# Item 600 Series – 2024 Specification Book Rewrite

September 19, 2024

## Item 610 – Roadway Illumination Assemblies, (Cont'd)

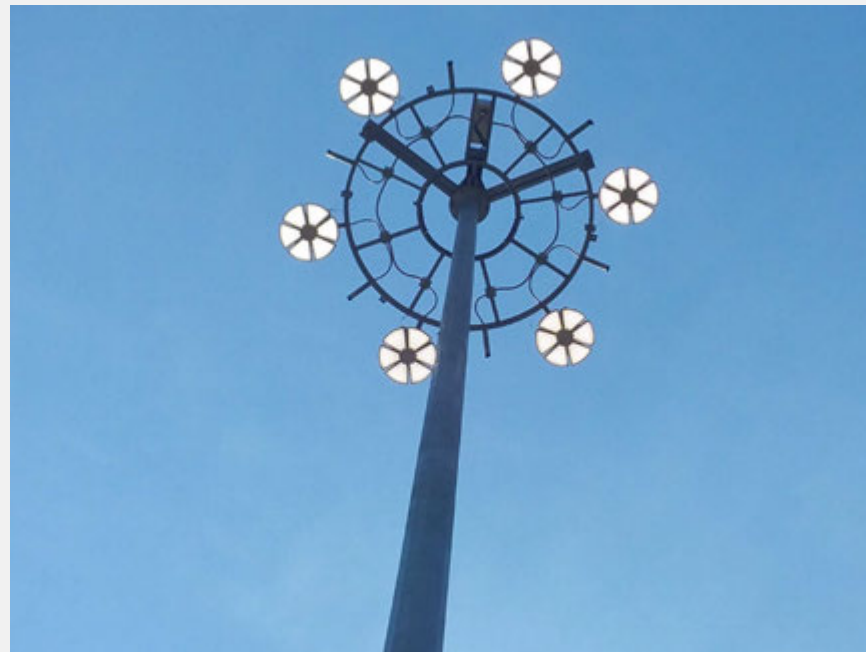
- Construction – *"Sampling fixtures for testing in accordance with Tex-1110-T"* was removed.
- Construction: Relocation – added clean optical assembly when reusing
- Construction: Replace Luminaires – added replace conductors and breakaway fuseholders when necessary.

## Item 614 – High Mast Illumination Assemblies, (Cont'd)

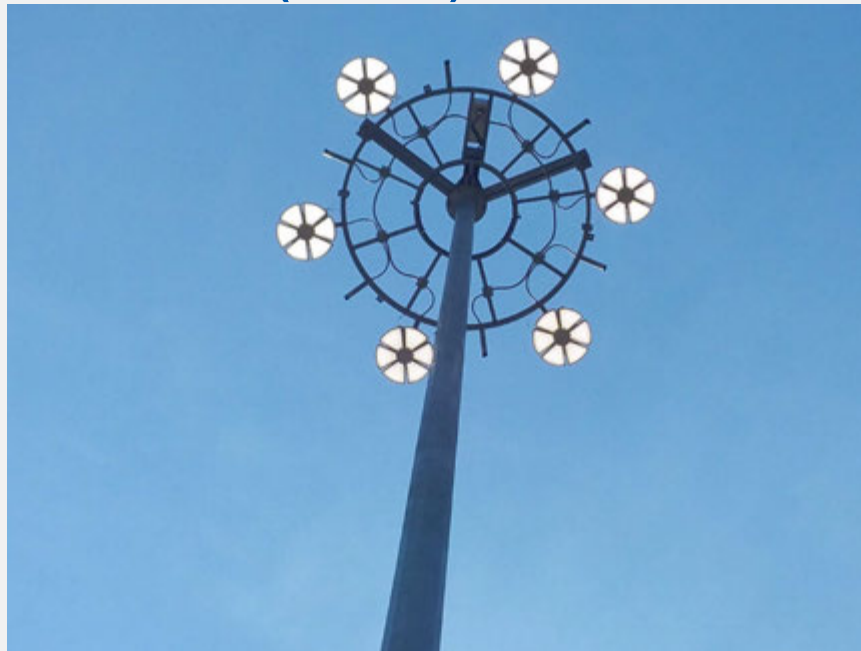
- Replace Luminaires – added instructions to Construction, Measurement, and Payment sections for replacement of high mast luminaires.

## Item 647 – Large Roadside Sign Supports and Assemblies

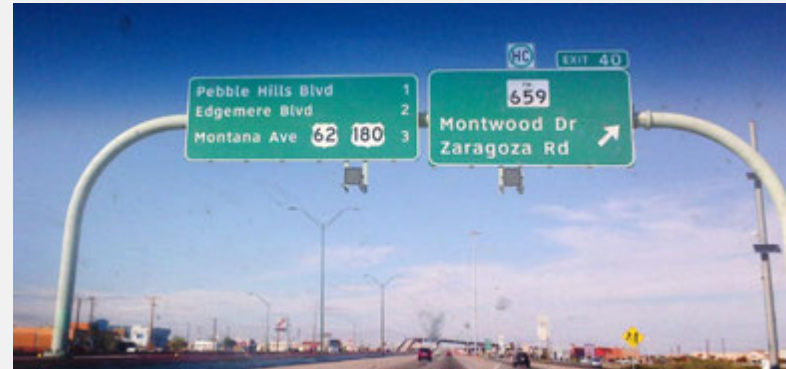
- Construction
  - Deleted text within 3.2 Installation. "At the Contractor's option, sign supports may be cast in the concrete foundation as a unit. However, if installation is made with the upper post section attached, do not expose the support to traffic until the sign panel is properly affixed, unless otherwise approved."

- Deleted text with 3.3 Relocation. Or lengthen – "Reuse the existing supports and shorten **or lengthen** them as ..."

## Item 650 – Overhead Sign Supports, (Cont'd)

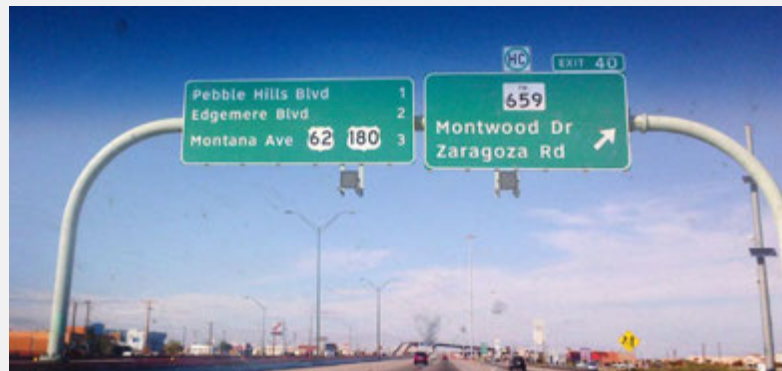
- Construction: Galvanizing
  - added note *"Provide punched, drilled or mechanically guided thermal-cut holes in steel parts or members, when allowed, before galvanizing."*

## Item 680 – Highway Traffic Signals

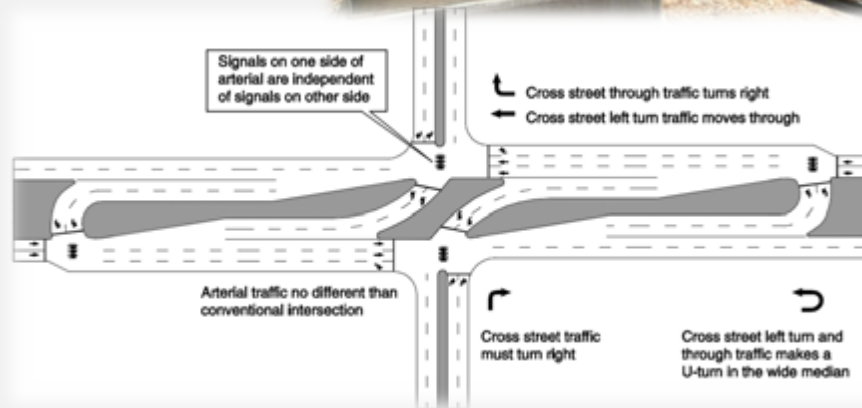
- Updated wiring guidance
  - 14AWG traffic signal cable
  - Cat 6 outer jacket coloring coding
  - Railroad preemption individual conductor color coding

- Cabinet
  - Components
  - Facing and railing
